Location Address: 1914-1920 Pierce Street

**SUBJECT:** Preliminary Site Plan and Design review for 32 Residential Units.

NEW 32 UNITS DEVELOPMENT AT  
**DOWNTOWN HOLLYWOOD**  
 1914 - 1920 PIERCE STREET HOLLYWOOD, FLORIDA 33020  
 (RESPONSE TO TAC COMMENTS DATED MARCH 20, 2023)

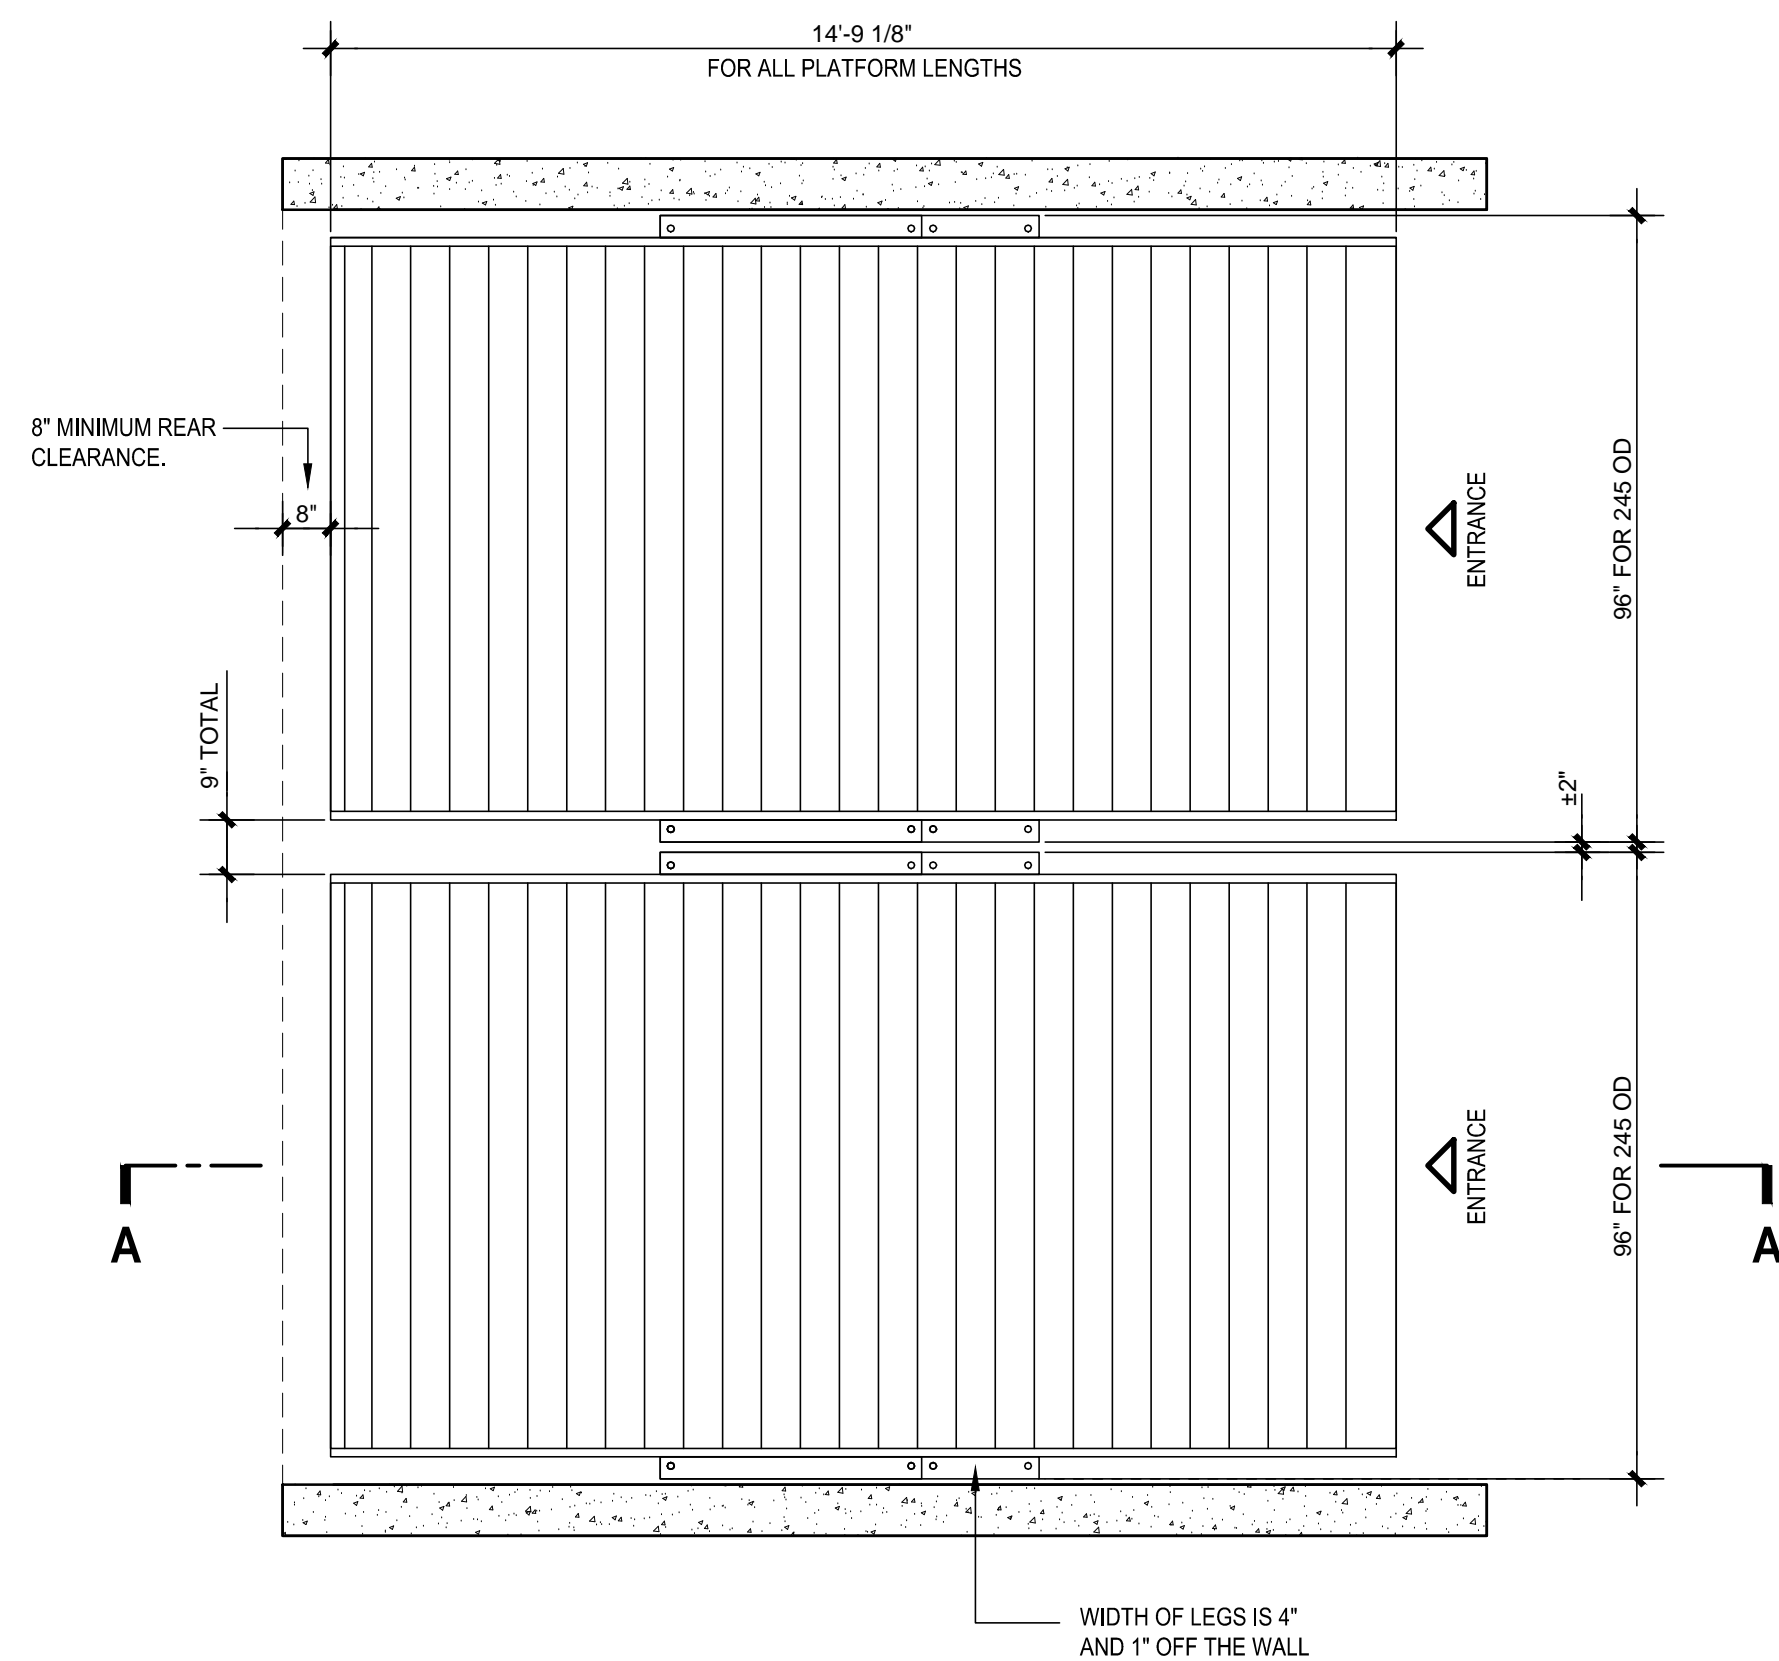
1. Indicate car lift specifications in notes on site plan.  
**Response: Refer to Revised A104 FOR Car Lift Notes and details.**
2. Indicate curbing type in the parking area.  
**Response: Refer to Revised Site Plan A100 for curbing identification.**

SHEET NO. **TD-1**  
OF

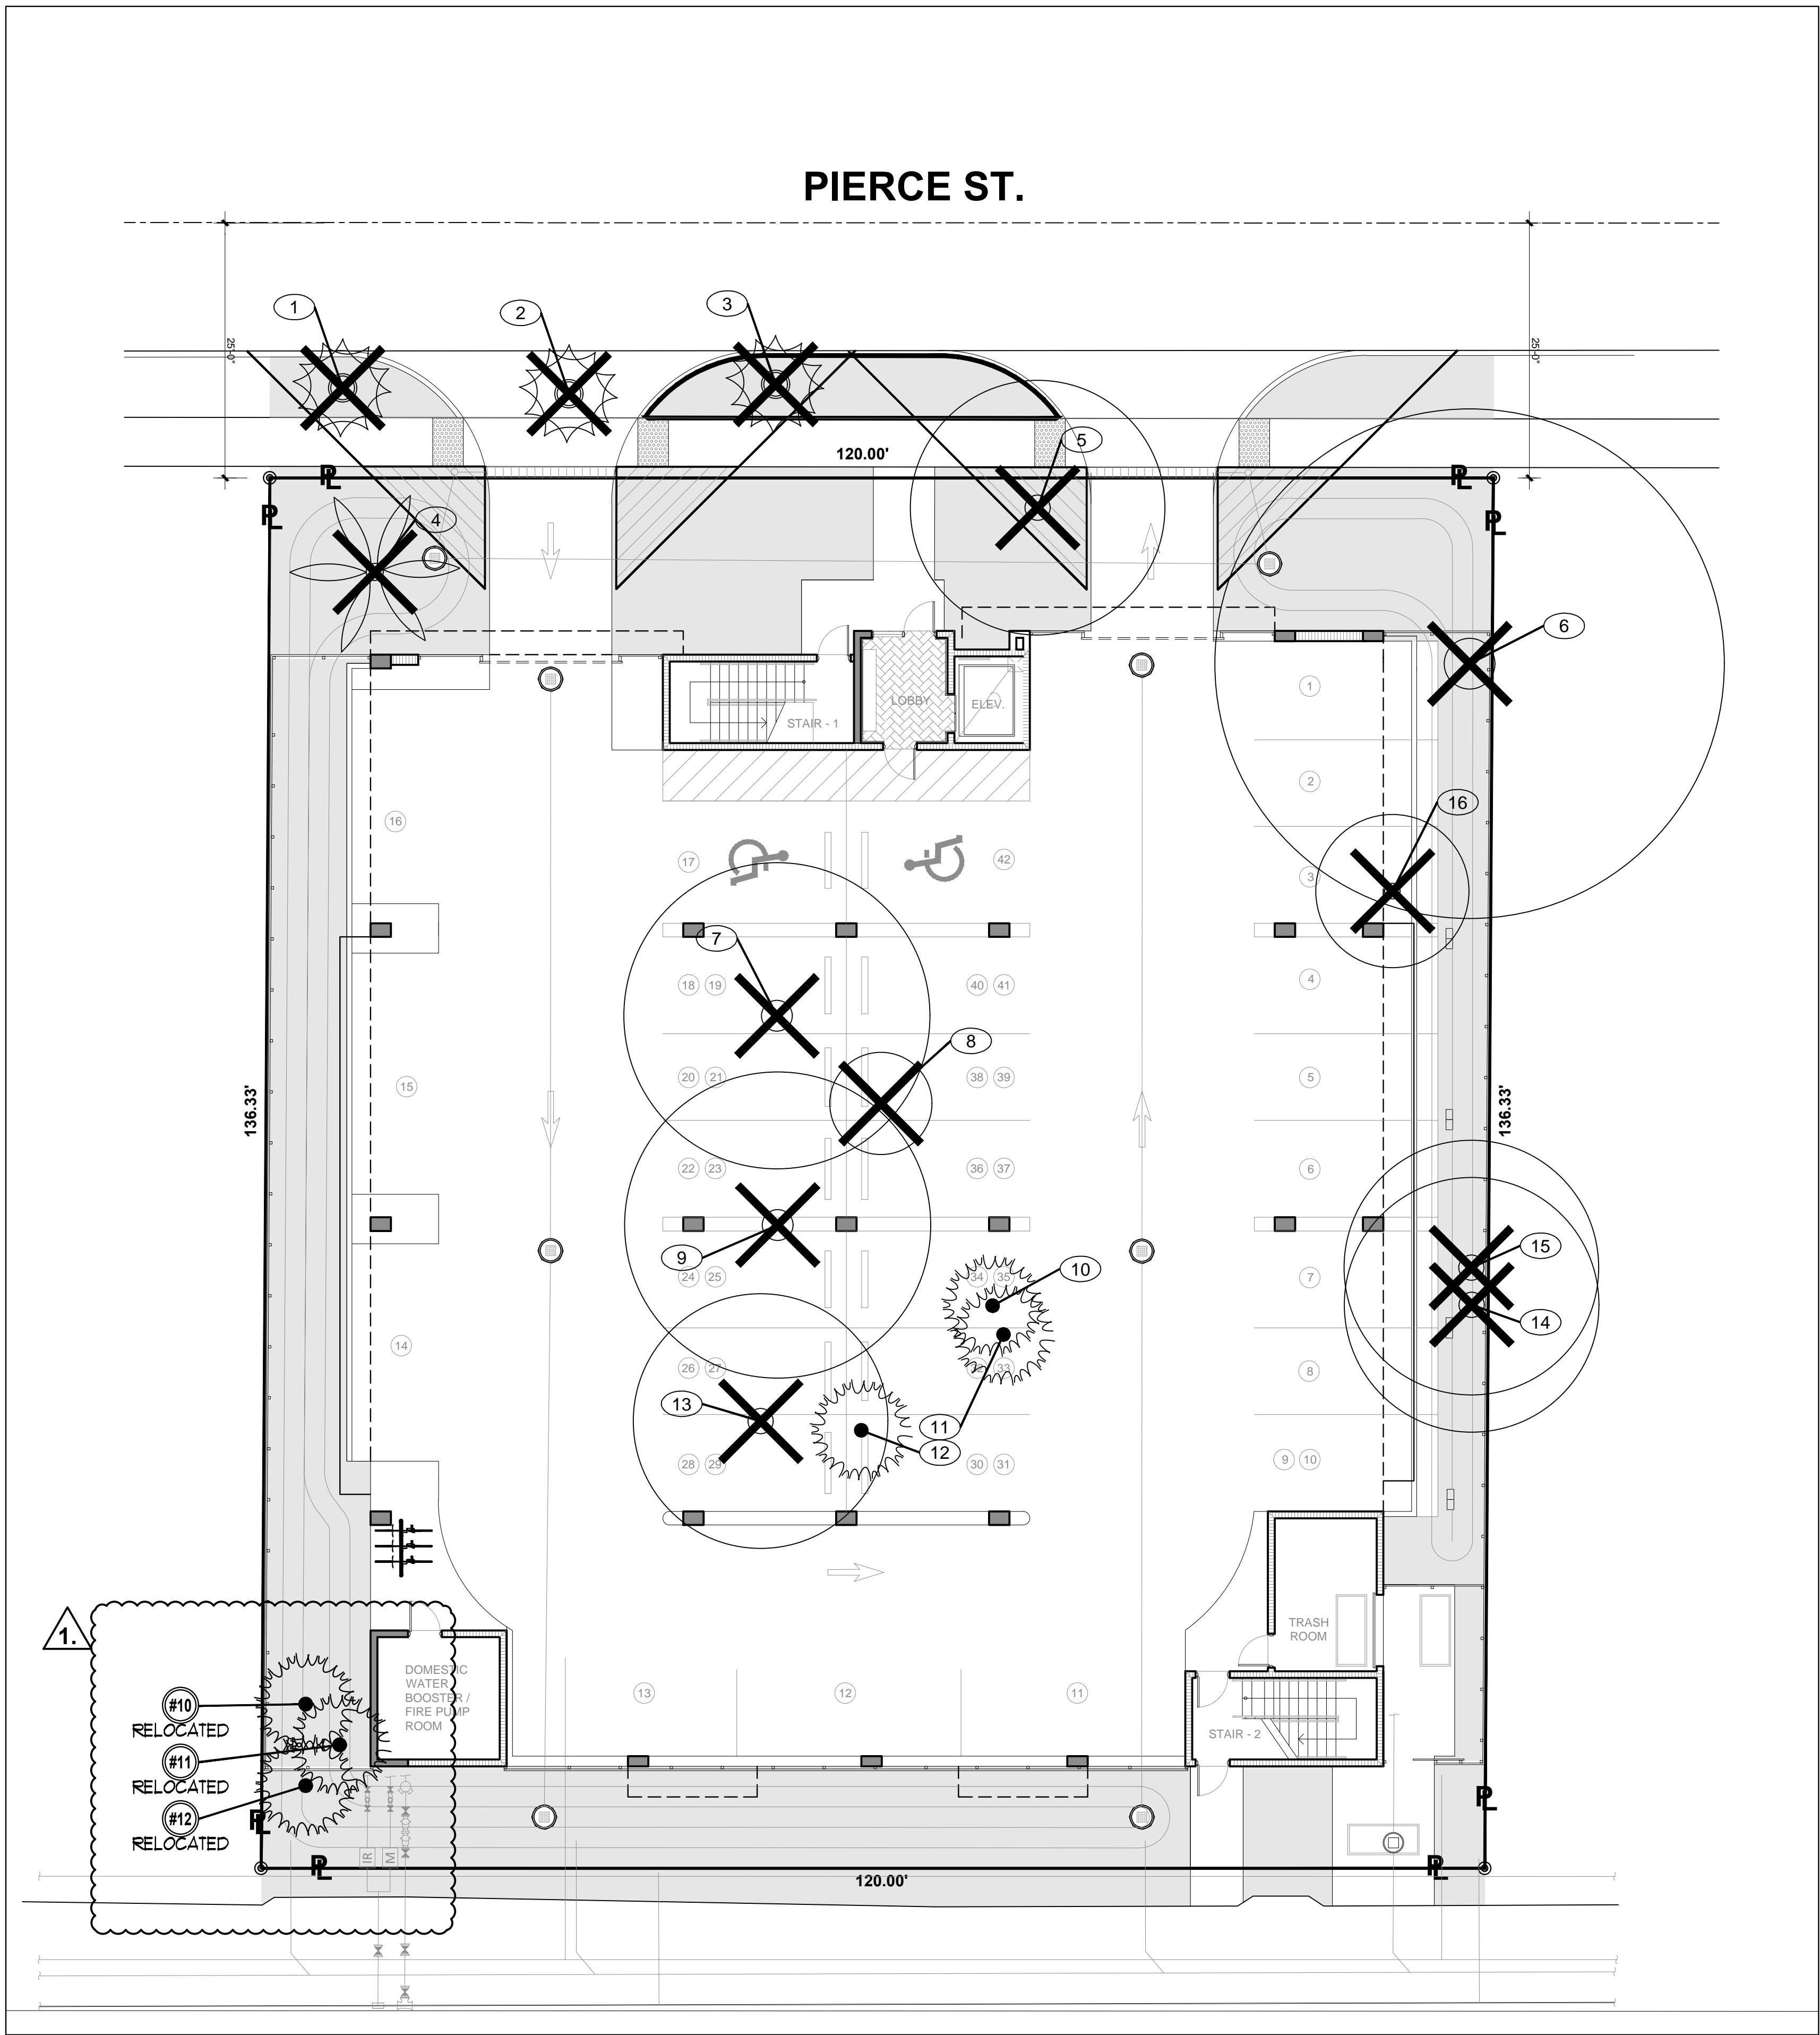
1. Tree disposition sheet is not taking into account the removal of tree #16. Revise mitigation chart/requirements and compensation.

3. Trees #14 & #15 are proposed to remain. Building construction will impact  $\frac{3}{4}$  of the critical root zone. Provide redesign or mitigation.

**RESPONSE: TREE DISPOSITION UPDATED PER COMMENT.**

**Response: TREES #14 AND #15 ARE NOW PROPOSED TO BE REMOVED PER COMMENT.**
